Re: *Petition of Duke Energy Florida, Inc., to Modify Scope of Existing Environmental Compliance Program; Docket No. 130301-EI*

**DUKE ENERGY FLORIDA, INC.'S RESPONSES TO
STAFF'S FIRST DATA REQUEST (NOS. 1-33)
Docket No. 130301-EI**

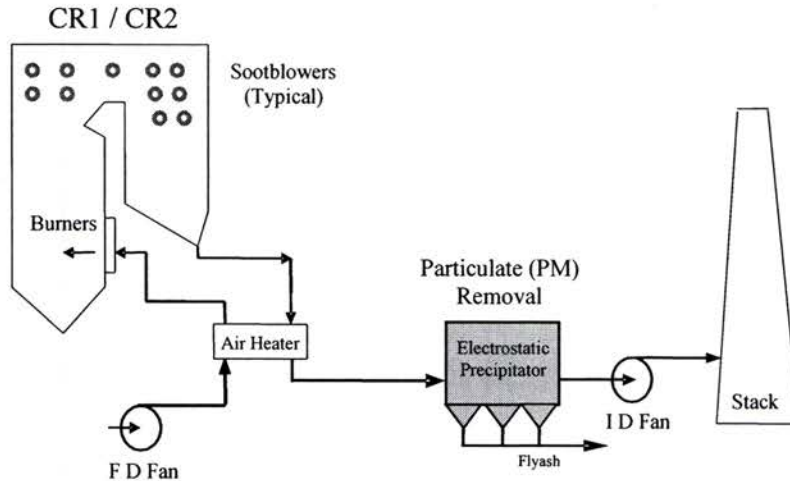
22. Please provide a simplified diagram of Crystal River Units 1 and 2 with and without the emission control projects proposed in the Petition.

Please see the Diagram below with the proposed new emission control systems:
